UNITED STATES PATENT AND TRADEMARK OFFICE

| Office Action Summary | Application No. 10/697,989 | Applicant(s) TETSUKA, TOSHIO | |

DETAILED ACTION

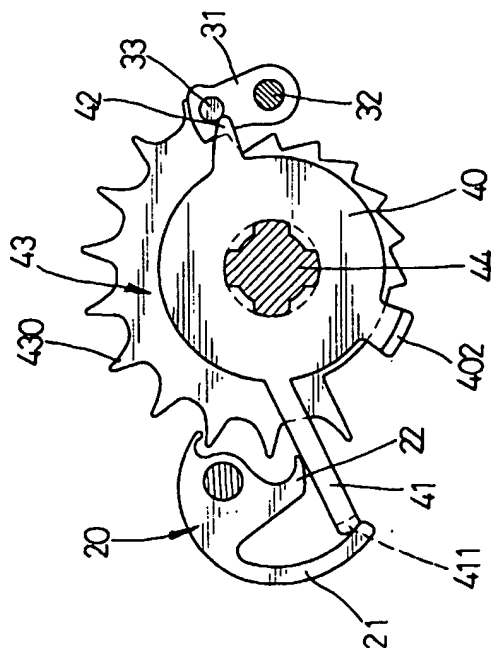
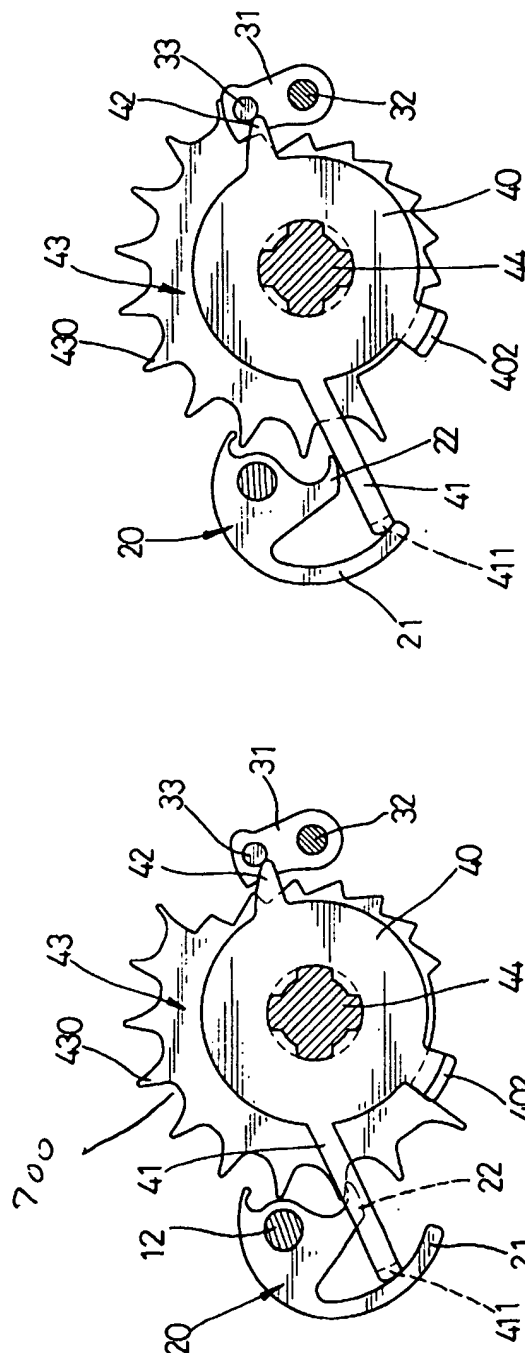
Re claims 1-9 Ueng discloses a(n):

- Operator actuating member (10)
- Positioning mechanism including:
 - First member and second members (43,20)
 - Buffering member [430; tooth 430 buffers the fall and movement of 20
(see Figure 5)]
- Recess (700, See Figure 3, marked by examiner)
- Ratchet element (43)
- Pawl element (20)
- Winding element (52)

But does not disclose a buffering member that is a coating.
